To: T10 Technical Committee
From: Jim Hatfield, Seagate (James.C.Hatfield@seagate.com),
Rob Elliott, HP (elliott@hp.com)
Date: June 12, 2007
Subject: SAT-2 Translation of Large Physical Blocks

Overview

ATA8-ACS defines how an ATA device reports its geometry of logical and physical sectors. SBC-3 defines how a SCSI device server reports similar information. This proposal describes how to map these geometry parameters between ATA and SCSI.

Figure 1- LOWEST ALIGNED LOGICAL BLOCK ADDRESS field examples

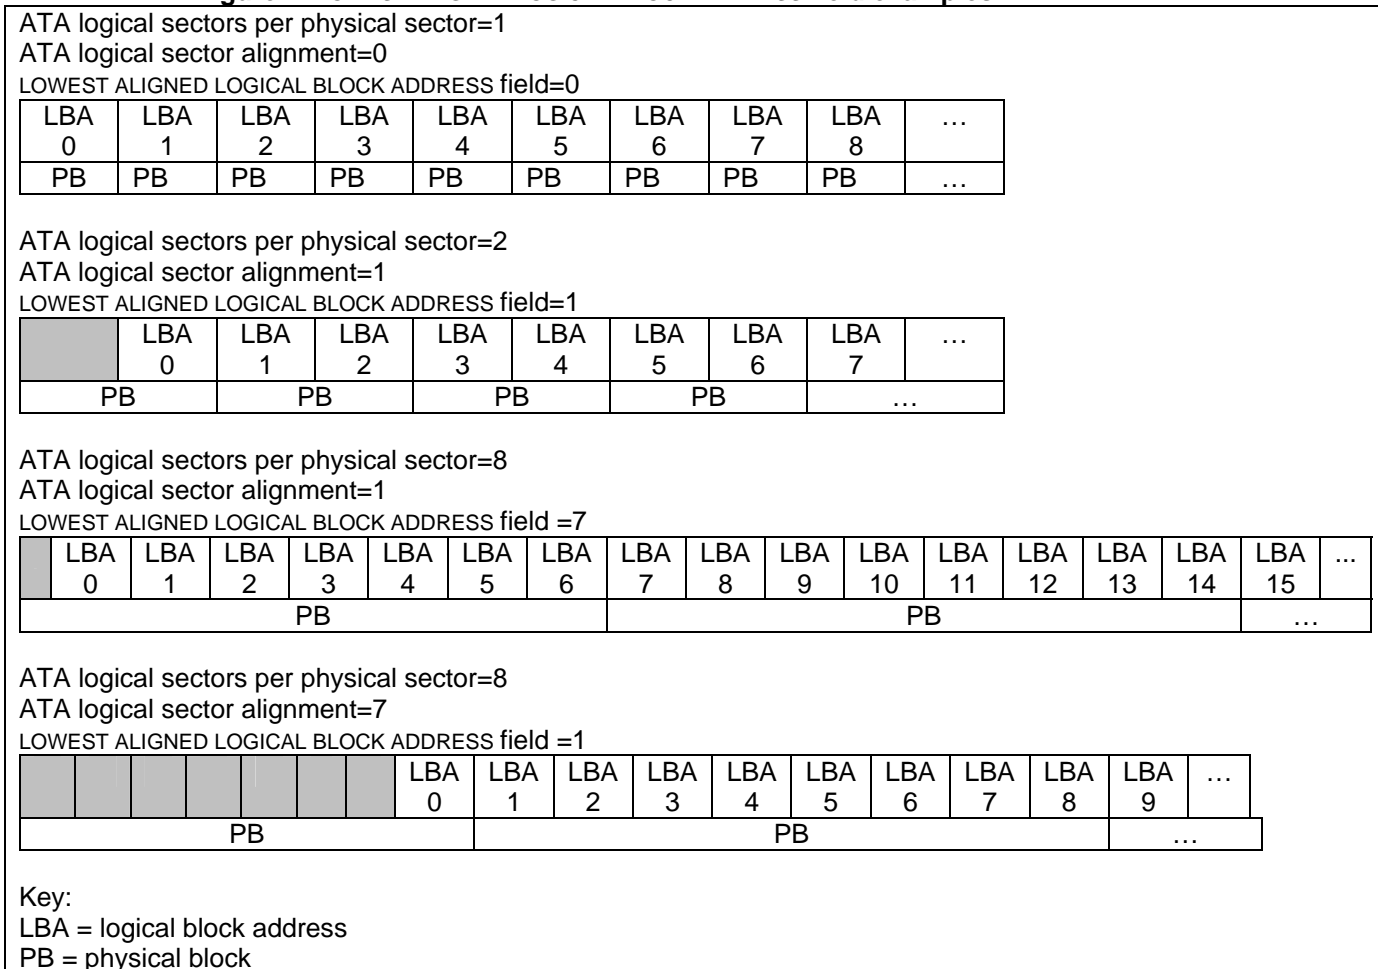
[Figure 1 shows examples of LOWEST ALIGNED LOGICAL BLOCK ADDRESS field values for various values of ATA logical sector alignment and ATA logical sectors per physical sector.](#)

[Editor's note: Figure must be converted into Visio](#)

LOWEST ALIGNED LOGICAL BLOCK ADDRESS	If the SATL implements direct logical block mapping (see 3.1.33) then this field shall contain the following value: _____ (a - b) modulo a where: _____ a is the ATA logical sectors per physical sector (see 3.1.xx) _____ b is the ATA logical sector alignment (see 3.1.yy) Otherwise, this field is unspecified (see 3.4.2).
^a The values reported in the RETURNED LOGICAL BLOCK ADDRESS field and the LOGICAL BLOCK LENGTH IN BYTES field shall be such that the logical unit capacity (see 3.1.49) is less than or equal to the ATA device capacity (see 3.1.9) .
